**Well Name:** ANTELOPE FED

**Operator:** KAISER FRANCIS OIL  
COMPANY

### Notice of Intent

**Type of Action:** Plug and Abandonment

Proposed P&A WELL DIAGRAM - 9/17/24

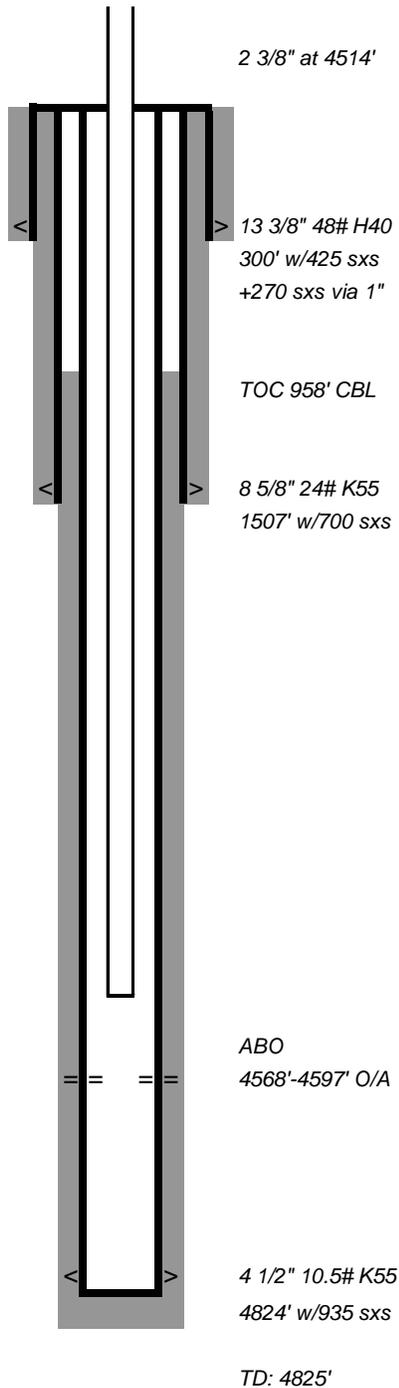
Proposed Plugging Procedure.  
Pull tubing.  
Set CIBP @ 4540. Spot 20sx Class C on top of CIBP.  
Circ hole w/ NMOCD-approved mud. Test plug to 500#.  
Spot 20sx Class C f/ 1557-1457 WOC & Tag  
Perf 4 350. Circ. w/ mud.  
Circ 100sx Class C f/ 350 to surface

Proposed P&A WELL DIAGRAM - 9/17/24

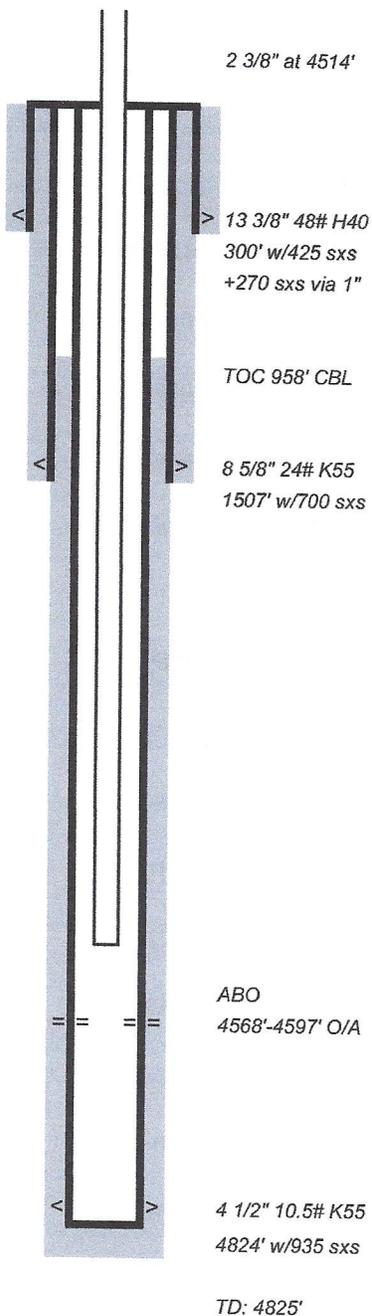
Spot 20sx Class C // ~~1557-1457~~ WOC & Tag (1700' to 1441') WOC & TAG.

Perf #350. Circ. w/ mud. @ 900' and squeeze to surface. (In 62 sx's / Out 169 sx's)  
Circ 400sx Class C // 350 to surface.  
Verify cement @ surface.

Spot cement from 2612' to 2286'.

Spot cement from 1700' to 1441'. WOC & TAG.

Spot cement from 2612' to 2486'. 25 sxs. (ABO @ 2562')

Spot 25 sxs on top of CIBP.

Spot cement from 4768' to 4620'. WOC & TAG. 25 sxs. (W.C. @ 4718')
